**Addendum No. 1**  
**January 13, 2023**

Project: Baltic High School Addition  
Baltic, South Dakots  
Arch Project No. 2957

Architect: Architecture Incorporated

NORTH WEST STORM SEWER

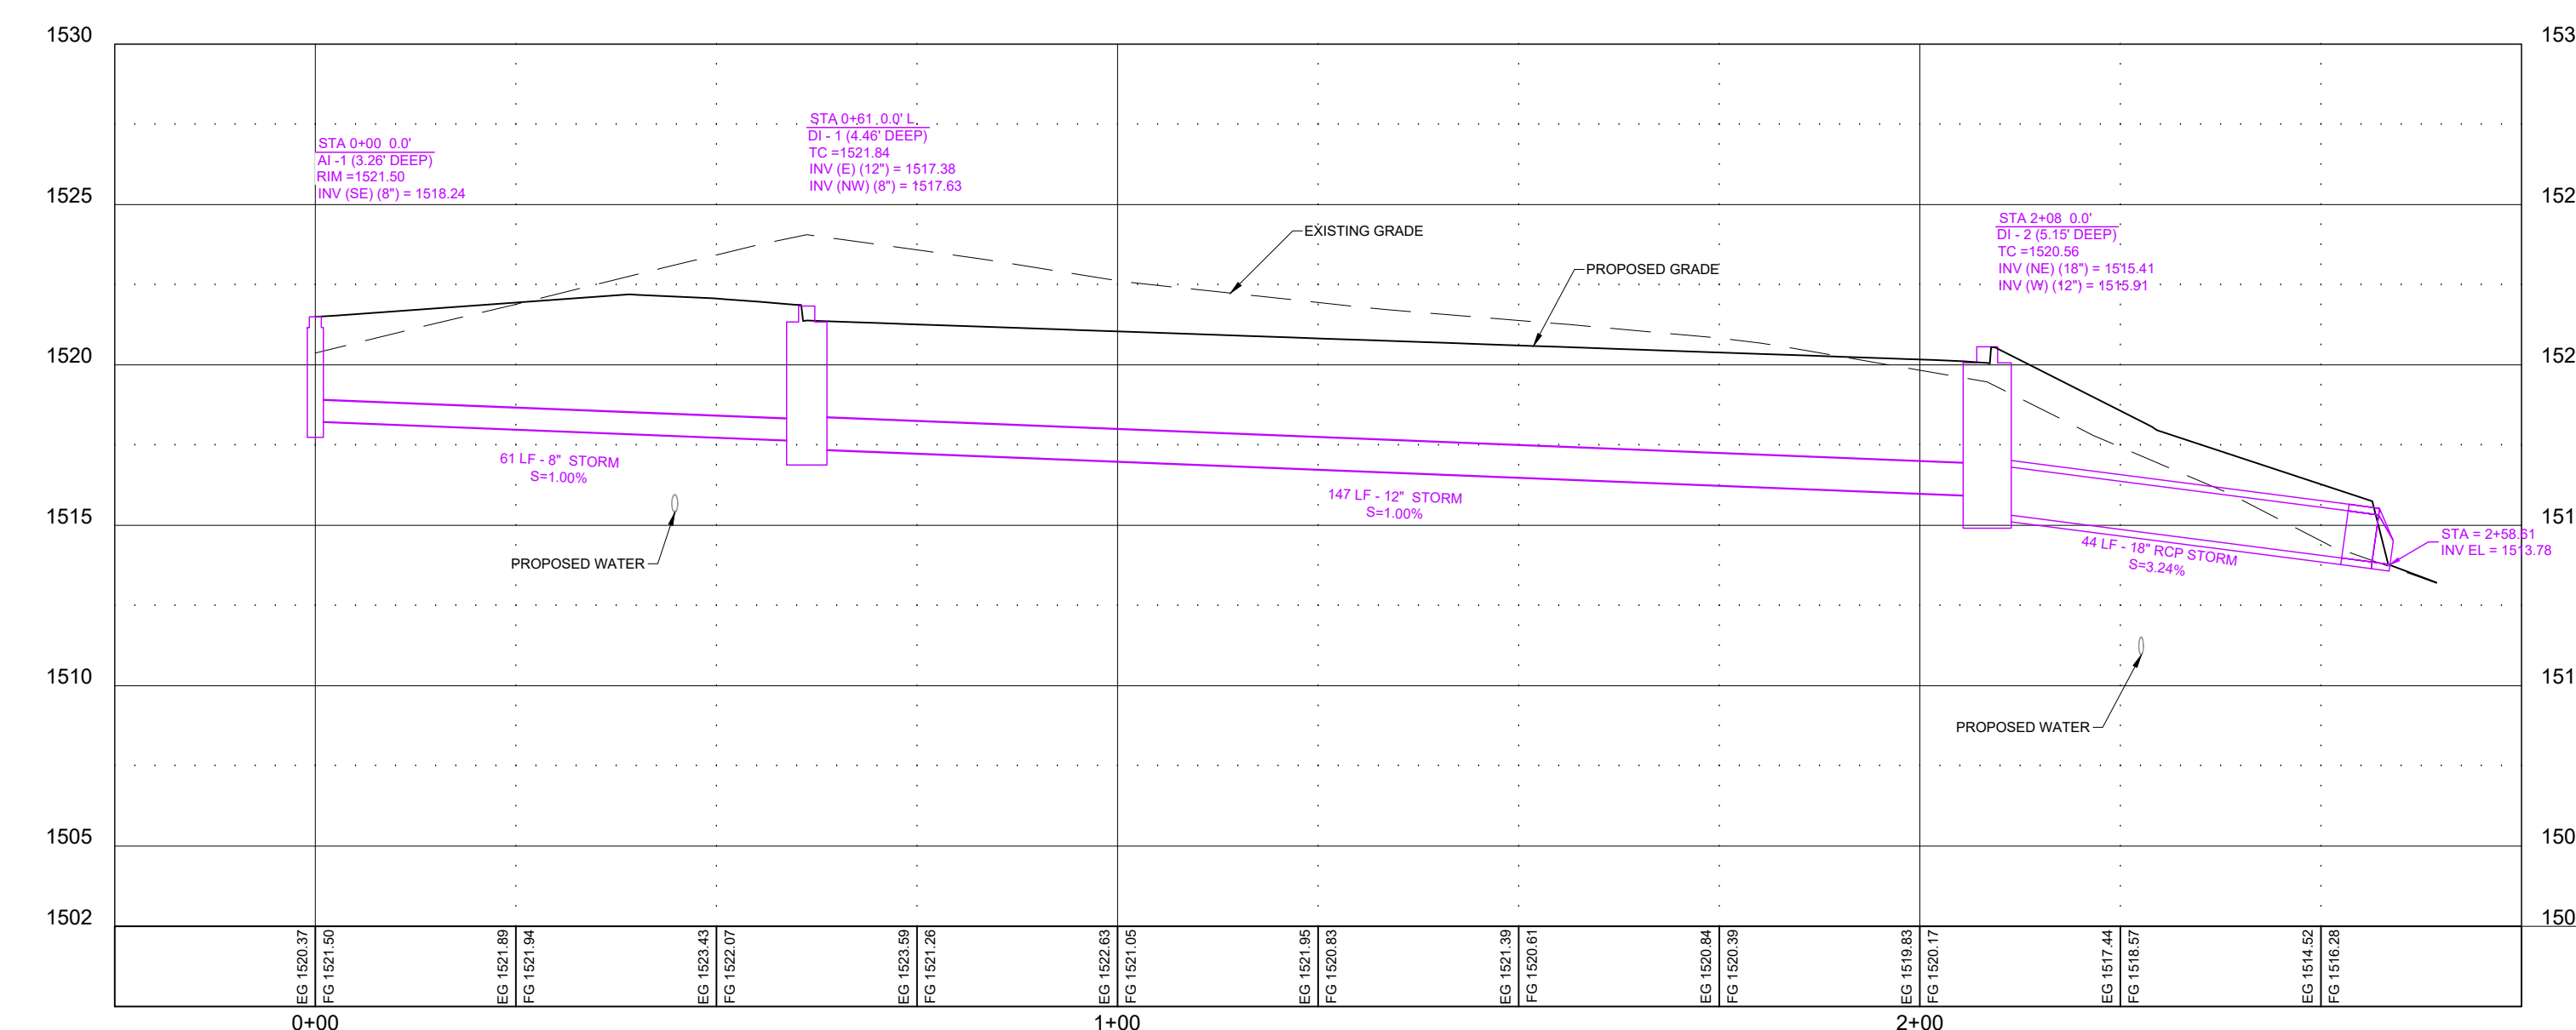
- 22) DRAWING 2.82 – STORM SEWER PLAN AND PROFILE
- a) The scale bar for this drawing Sheet has been updated / corrected; reference revised civil drawing Sheet 2.82 attached to the end of this addendum.

2.83

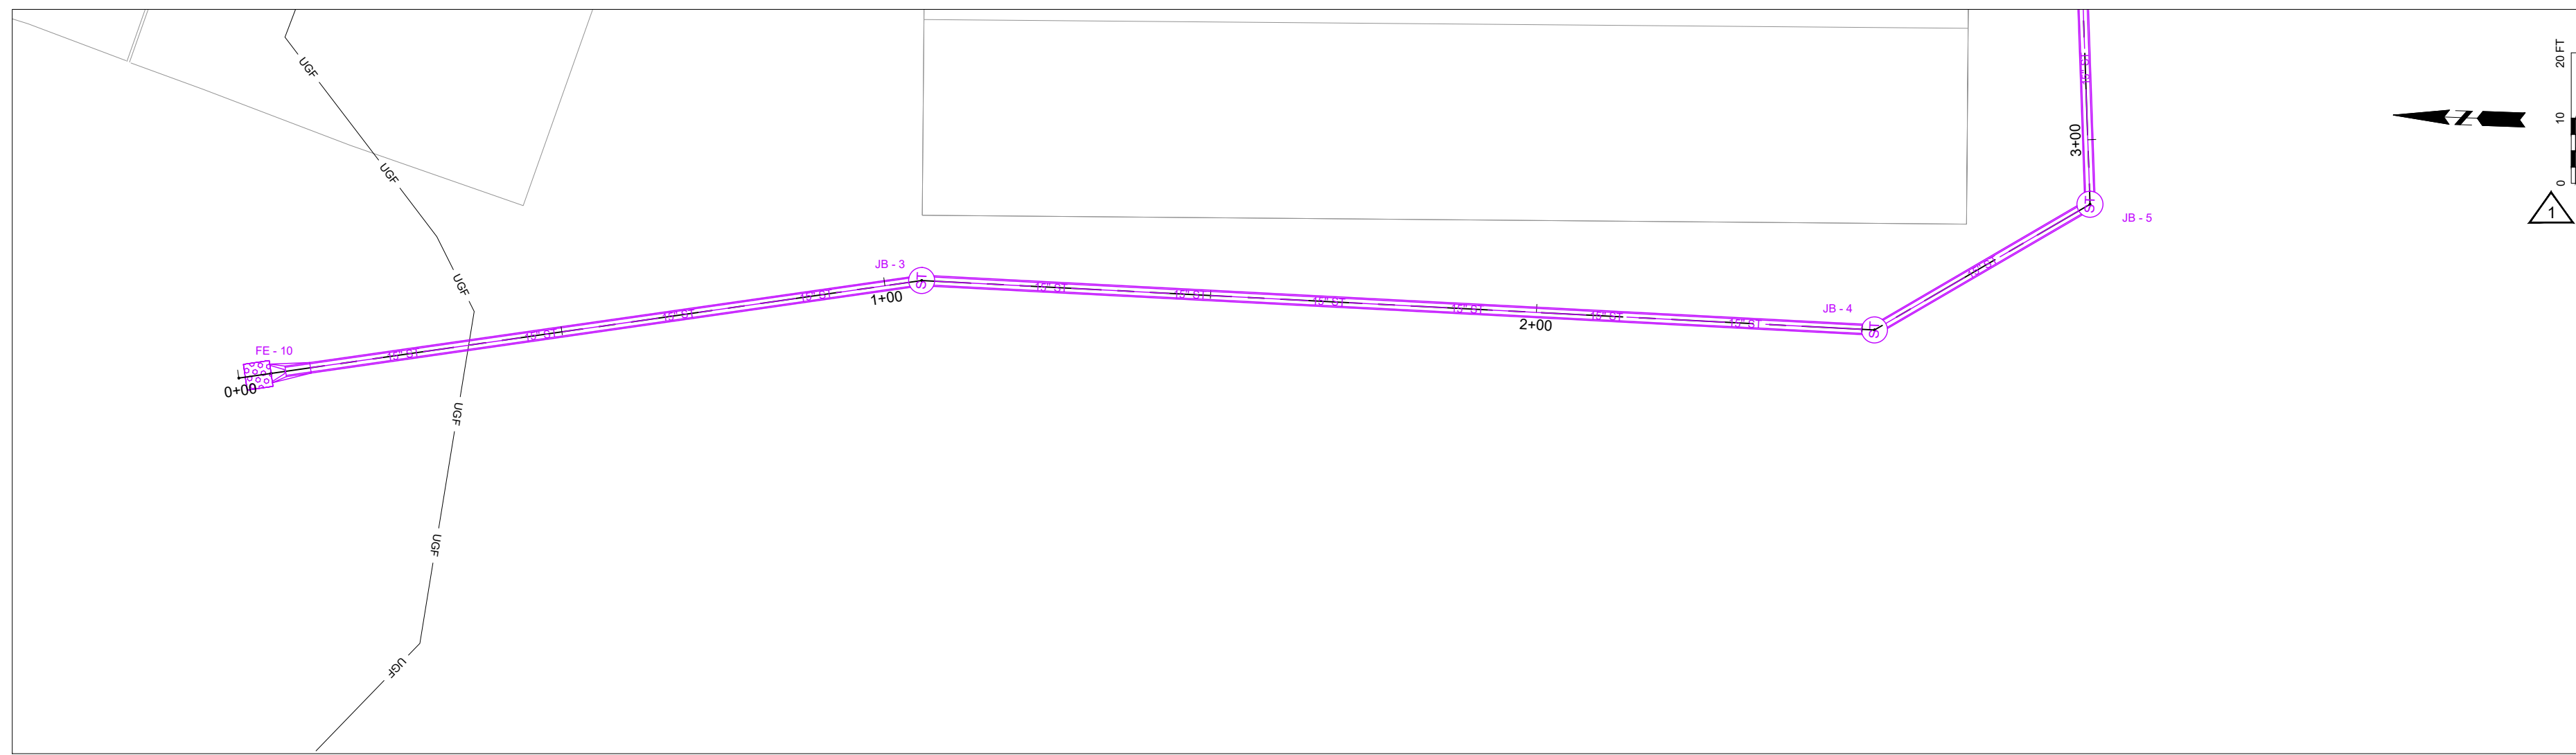
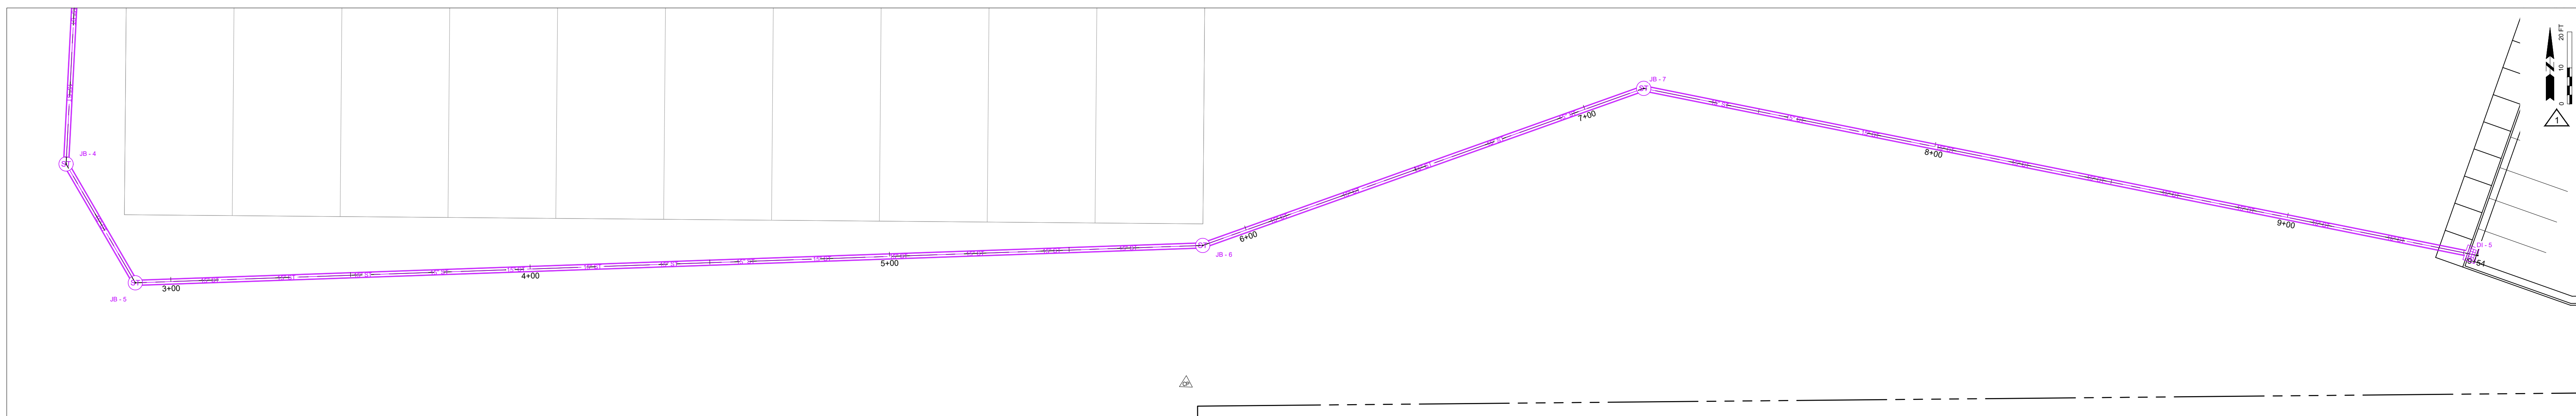
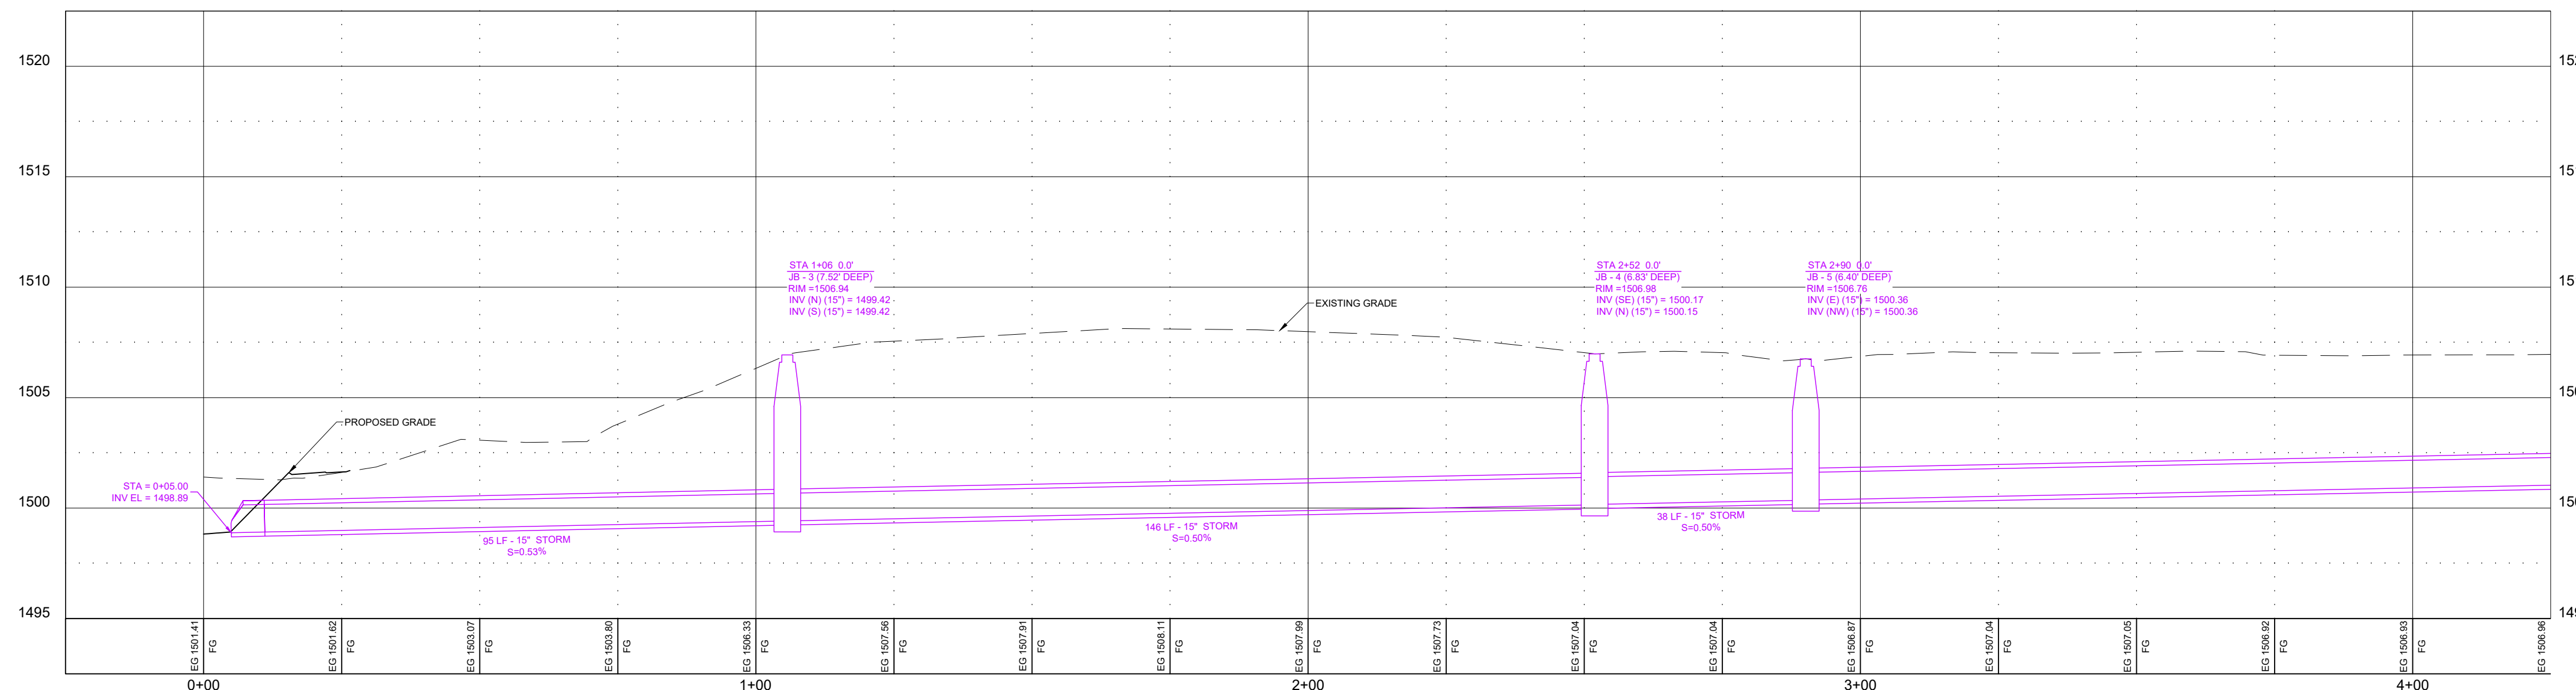
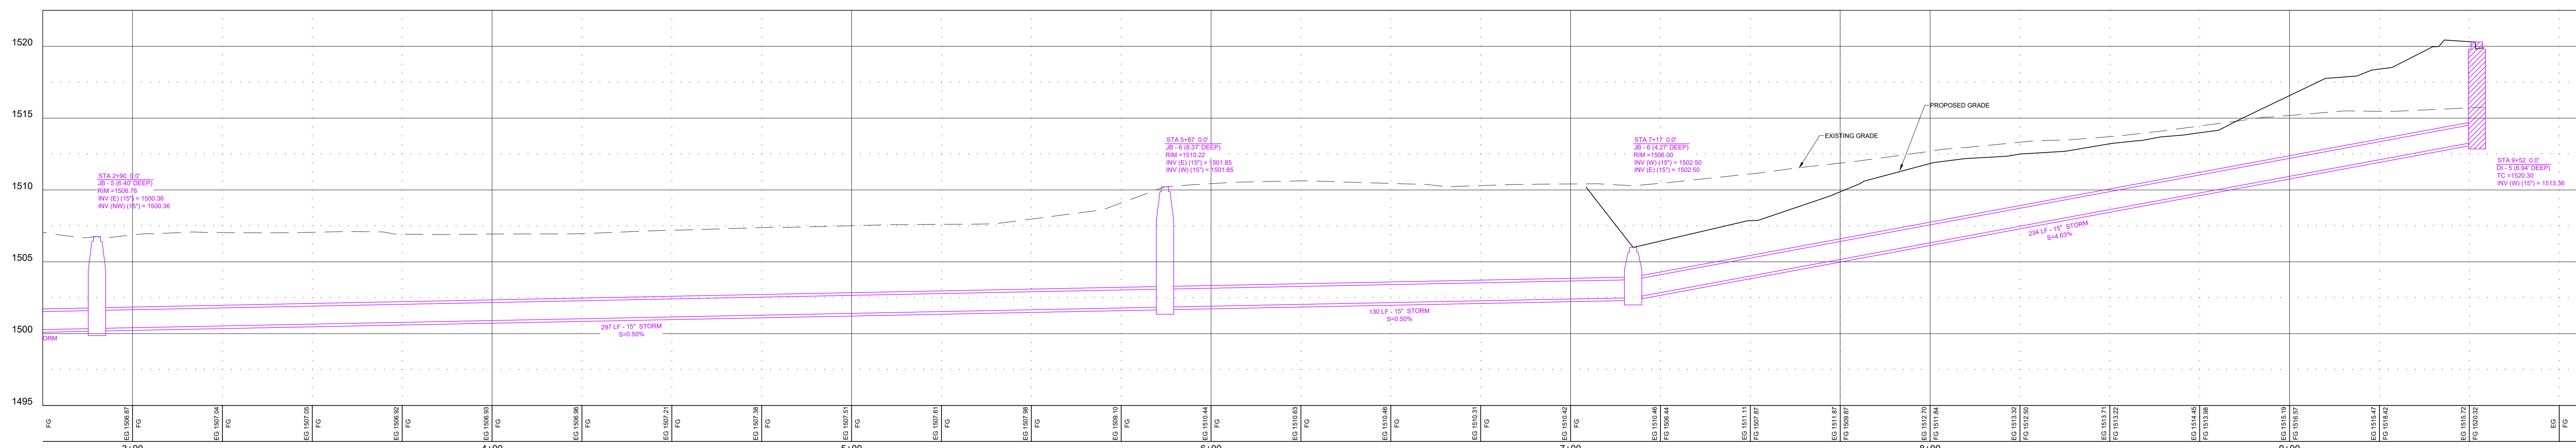
- 23) DRAWING 2.83 – STORM SEWER PLAN AND PROFILE
- a) The scale bar for this drawing Sheet has been updated / corrected; reference revised civil drawing Sheet 2.83 attached to the end of this addendum.

**F NORTH ELEVATION - AREA E**  
 5.10 SCALE: 1/8" = 1'-0"

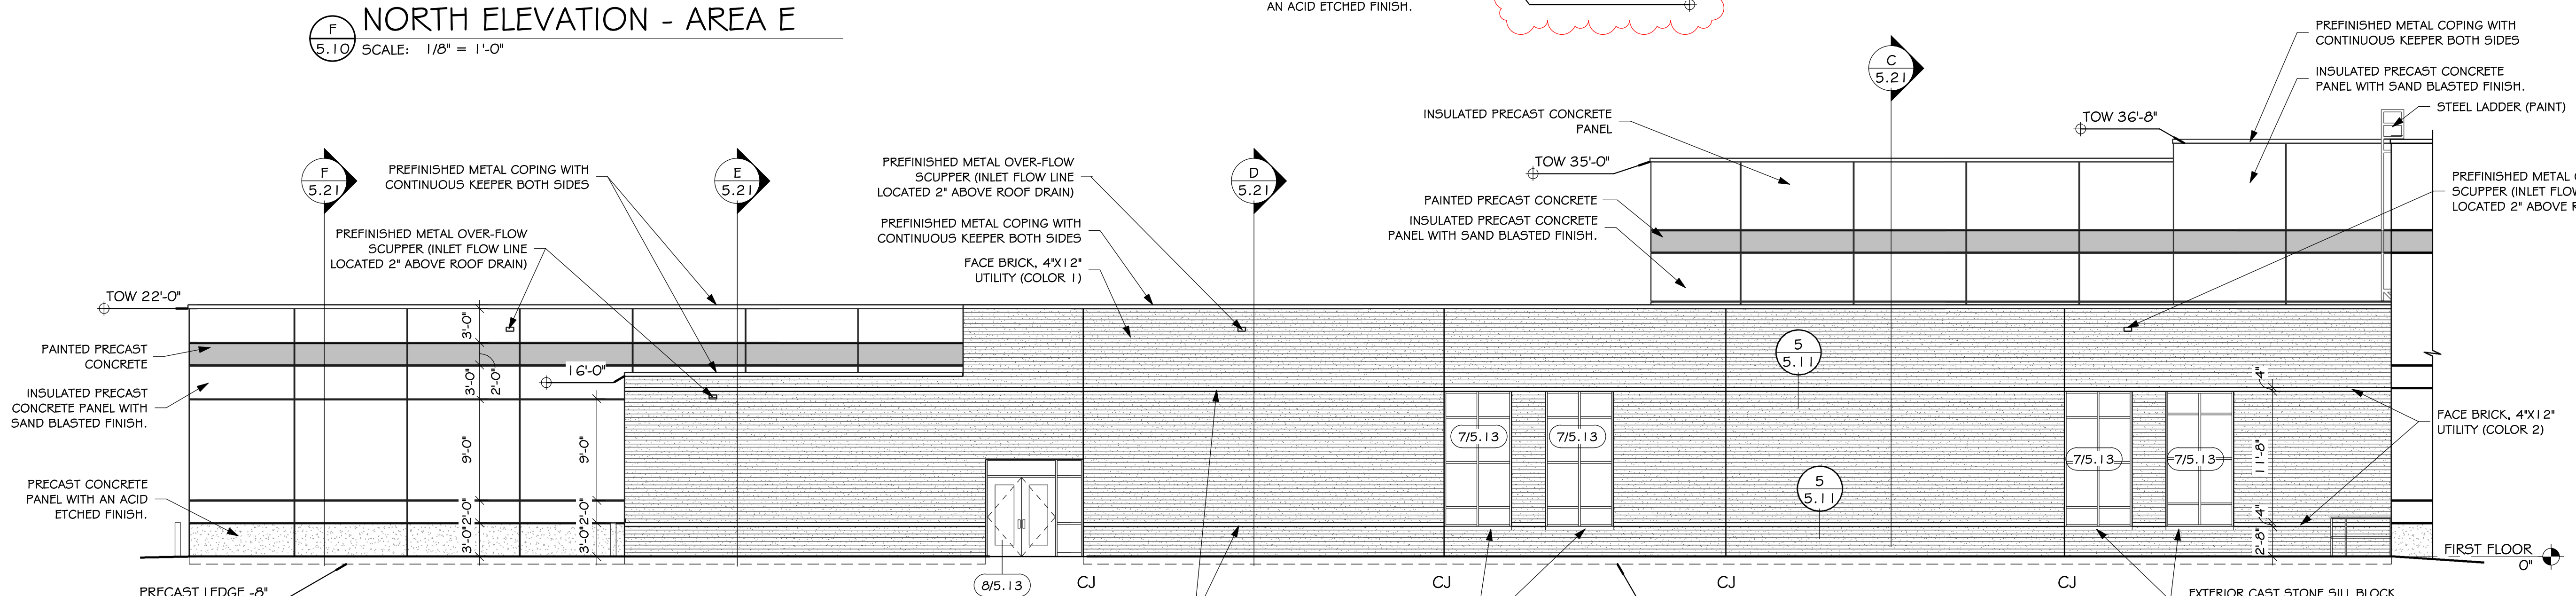
c. Provide [**12 inch**] high projected aluminum letters [**w/ clear anodized finish**] as shown per east exterior elevation F/5.10.

- a) Reference updated exterior elevation F/5.10 for clarifications to exterior lettering height; letters to be 12 inches high as shown.
- b) Reference updated exterior elevations F/5.10 & G/5.10 for cast stone sill keynotes.
- c) Reference updated exterior elevation G/5.10 which now shows brick reveal detail section callouts; see revised Sheet 5.11 for actual detail.
